# Response to Environment Agency Request for Information for Permit Variation Application – EPR/XP3832NV/V004

A permit variation application was submitted by Ramboll, on behalf of Angus Fire Limited (referred to hereafter as "Angus Fire" or "the Client") to the Environment Agency (EA) on 29 April 2025. The permit variation application was to vary the Environmental Permit EPR/XP3832NV/V004 for the Angus Fire site located at Station Road, Bentham, Nr Lancaster, LA2 7NA (the "Site").

The application proposed to update the existing permit to include a waste operation to allow for treatment of contained stormwater collected on the Site and post-treatment discharge through a new discharge point (W2). The new discharge point is located at the sampling point for the discharge.

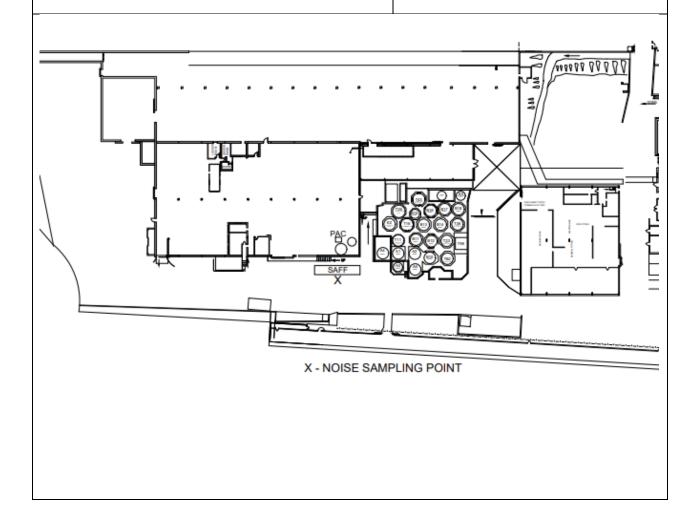
<u>Please confirm the operating hours of the ETP and how these will minimise the impact of noise and vibration on off-site receptors.</u>

Please confirm what processes and/or equipment in the SAFF plant may be expected to cause noise.

<u>Please define the expected noise levels from these processes and/or equipment.</u>

Noise monitoring was undertaken to demonstrate that the ETP would not result in an impact to off-site receptors.

The SAFF unit is containerised and the doors of the unit are kept closed except for access.

Inside the SAFF container adjacent to the SAFF primary processing vessel noise levels were recorded at 78.9dB(A)

External to the container, adjacent to the SAFF primary processing vessel and immediately outside the container (where it is expected that the highest noise levels would be recorded), the noise levels were recorded at 55.5 dB(A).
